Fargo VAMC – Refurbish Elevators and Replace Controls

Fargo, North Dakota
Project #19-2481

MARCH 26, 2024

ADDENDUM NO. 2

KEYNOTES: #

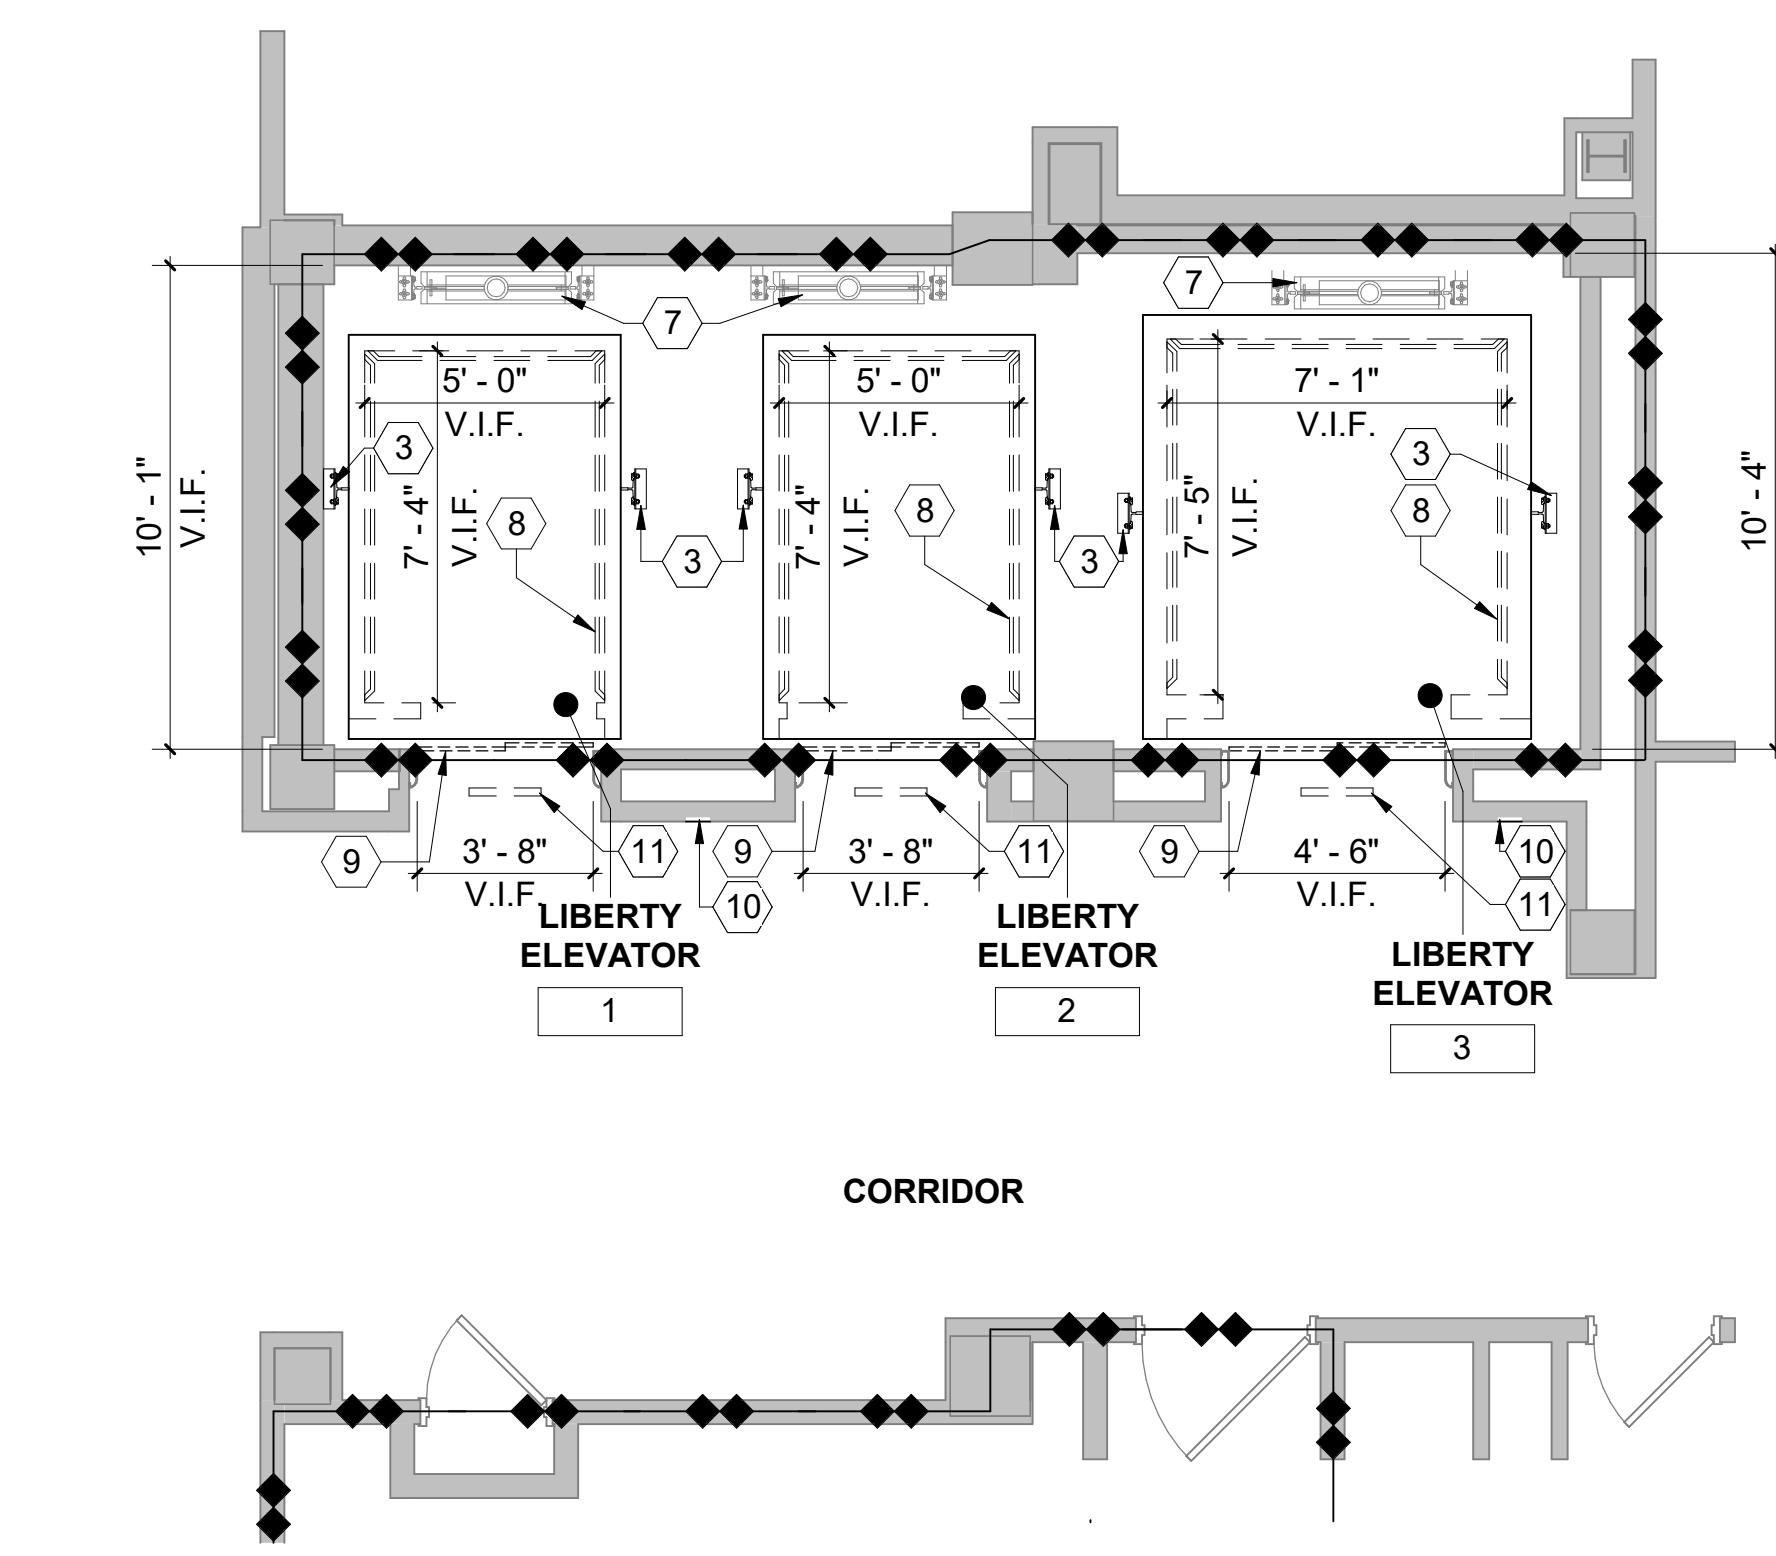
Drawing Sheet AD5.21 ENLARGED PLANS - DEMOLITION – See revised drawing sheet for the adjustment of keynotes # 3, 9, 14, 15.

13. NOT USED.
14. REPLACE EXISTING LOWER SECTION OF COUNTERWEIGHT ASSEMBLY GUIDERAILS IN ELEVATOR 7 AND 8 (APPROX 20 LF AT EACH RAIL). BALANCE COUNTERWEIGHT AS REQUIRED.

15. REPLACE LOWER SECTION OF EXISTING GUIDE RAILS (APPROX 20LF AT EACH RAIL) DUE TO WATER DAMAGE. APPLIES TO ELEVATOR 7 AND 8 ONLY.

Drawing Number
AD5.22

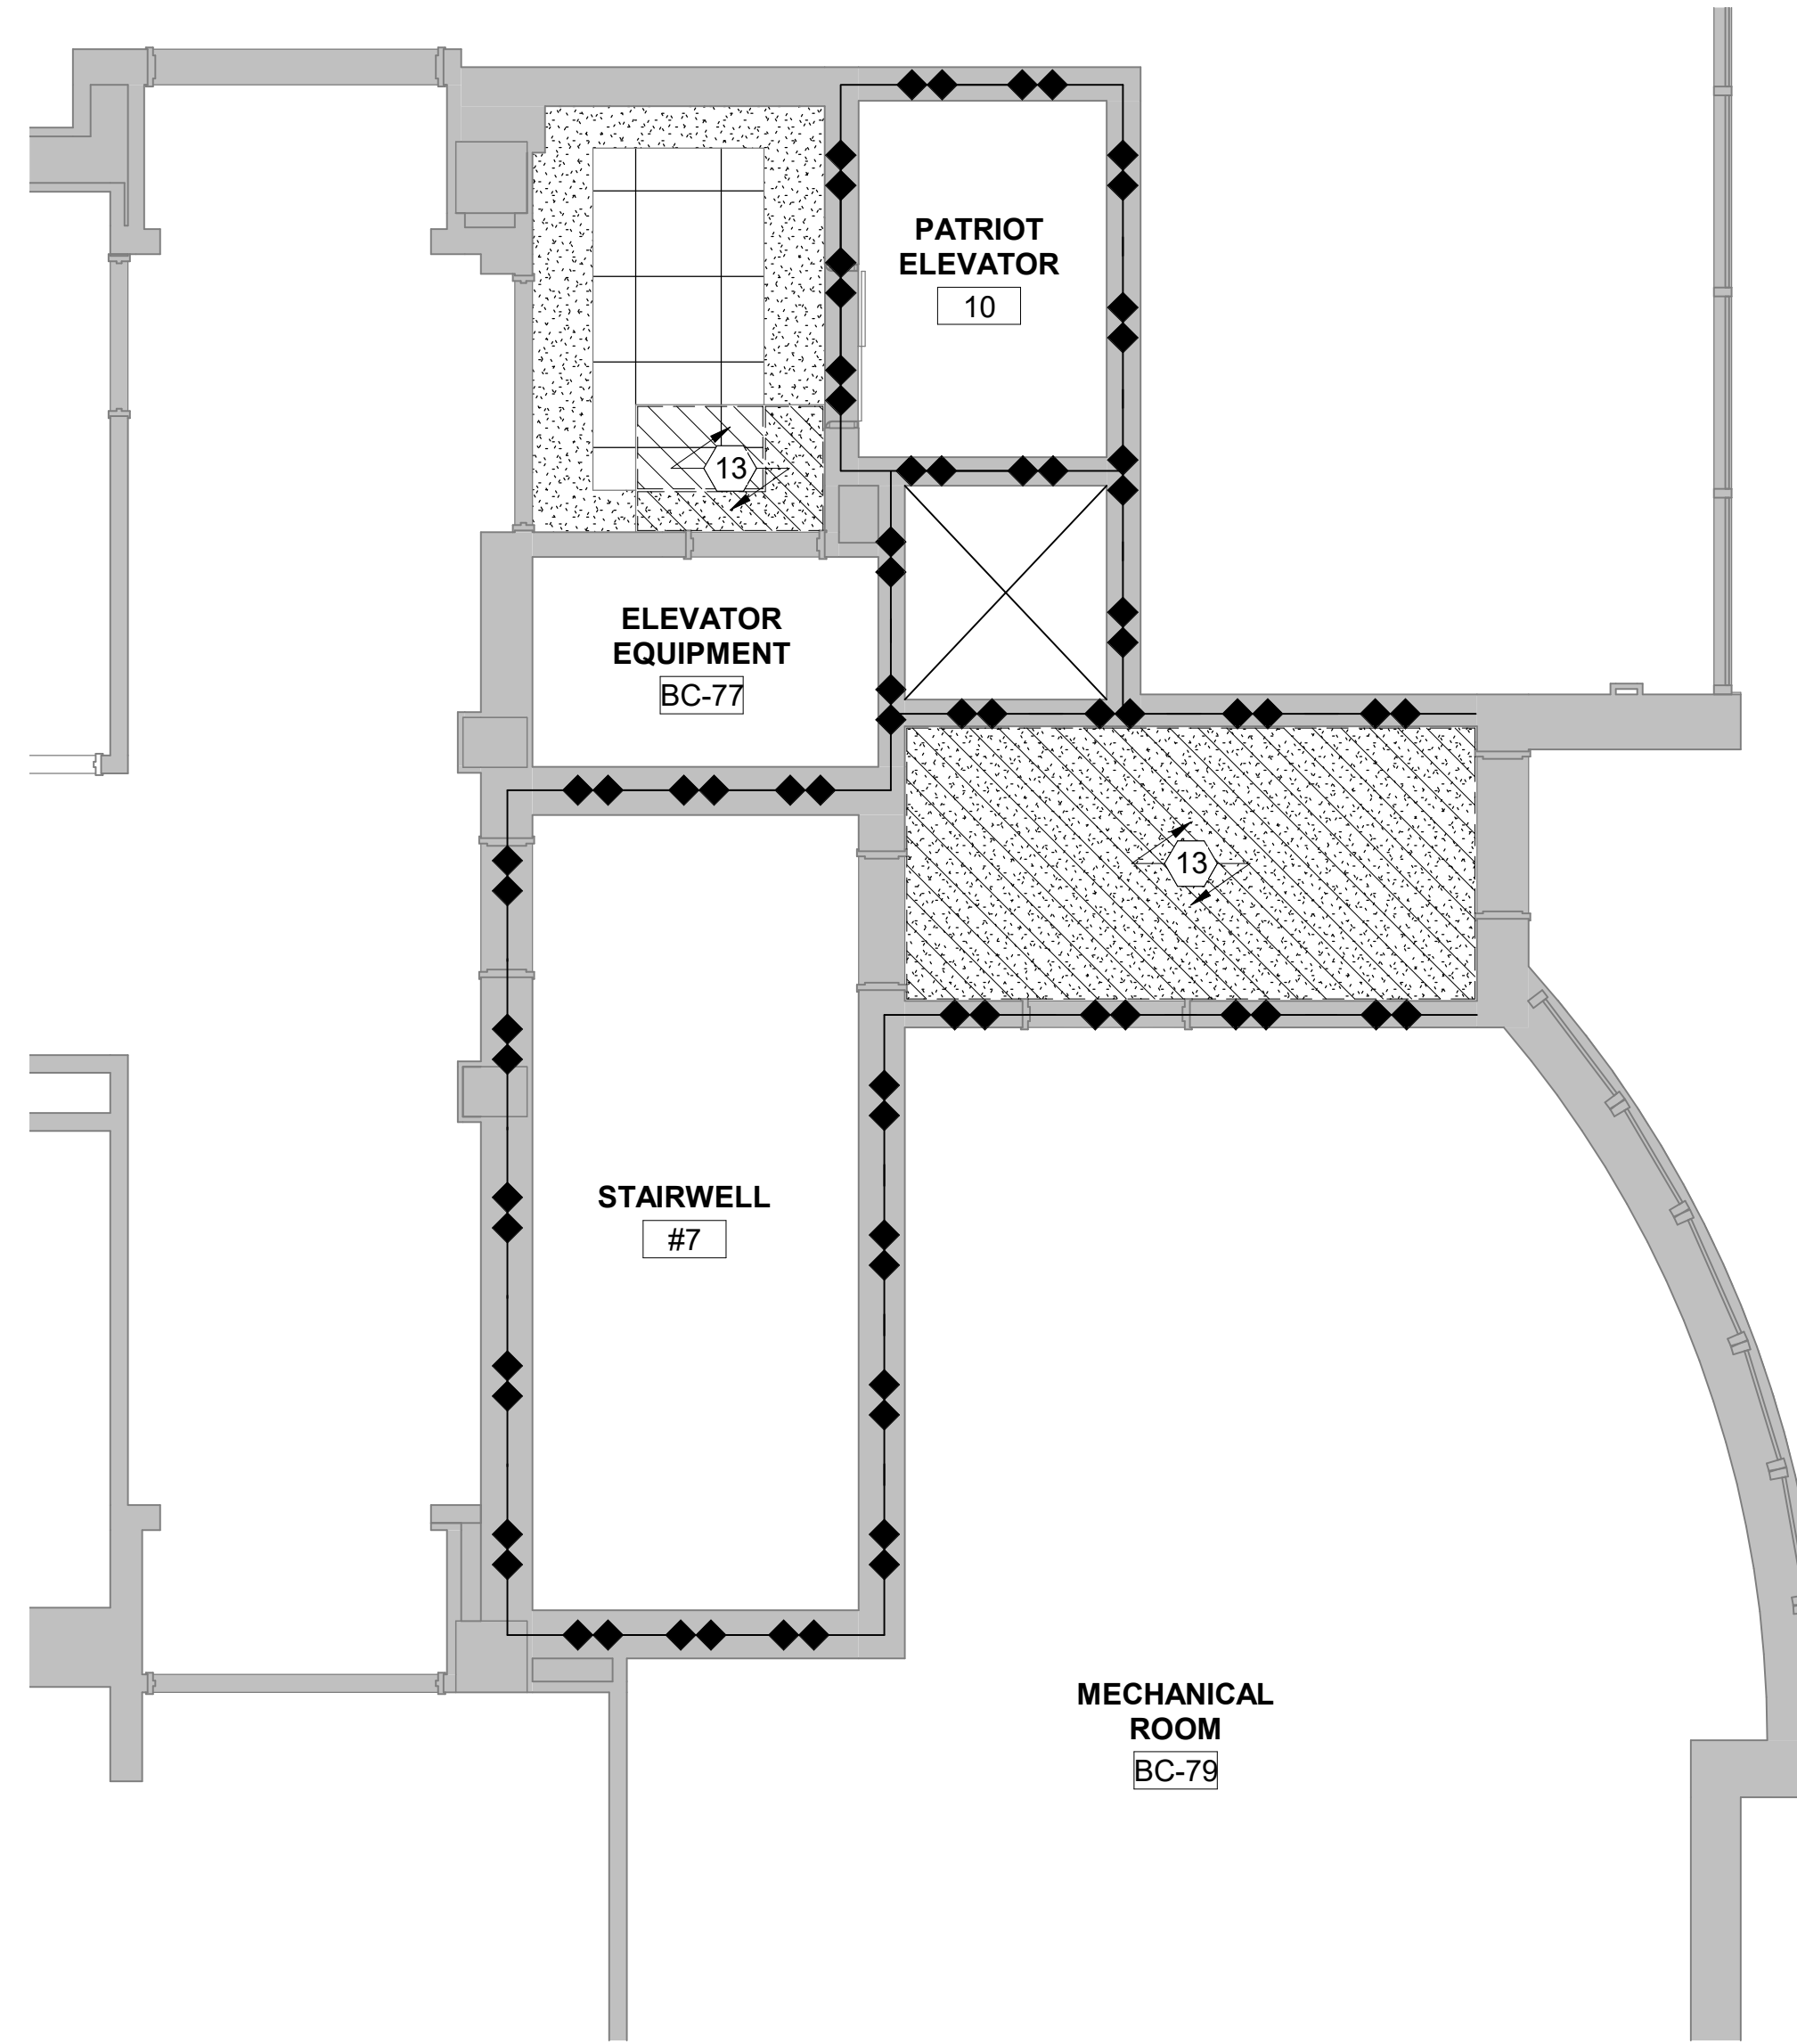
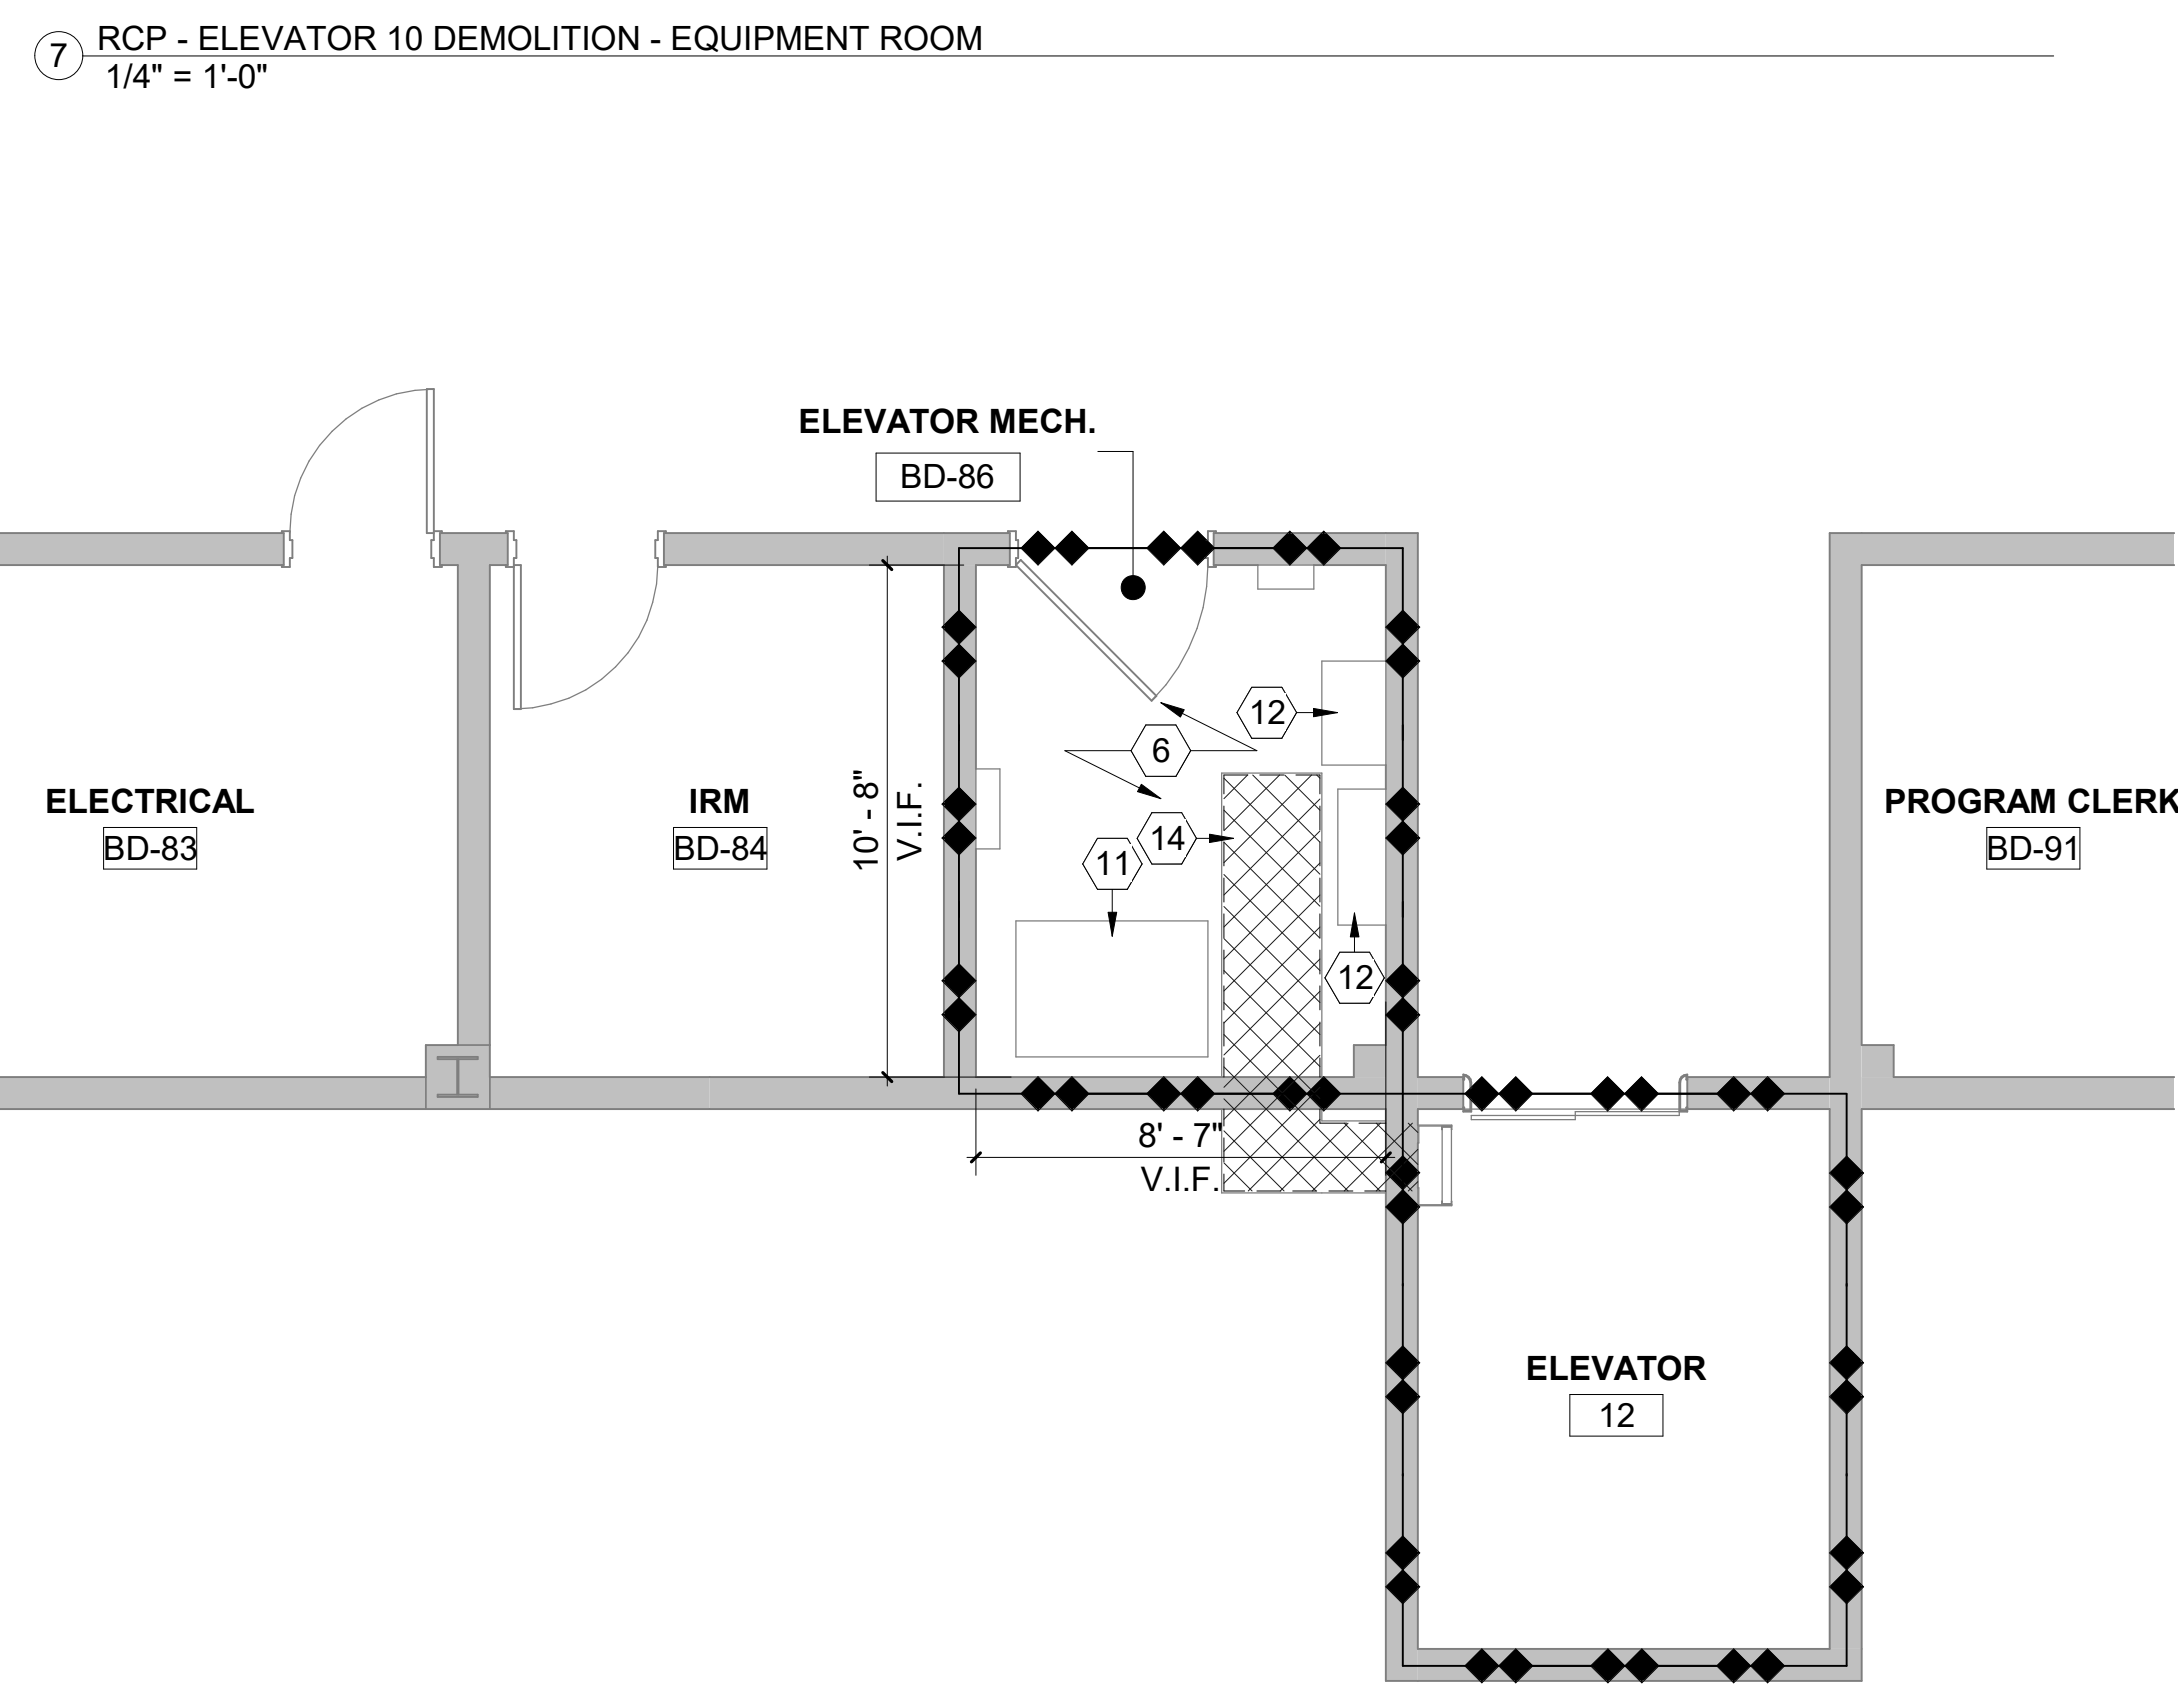
Drawing Sheet AD5.22 ENLARGED PLANS – PENTHOUSE / EQUIPMENT ROOMS - DEMOLITION – See revised drawing sheet for the adjustment of keynotes # 1.
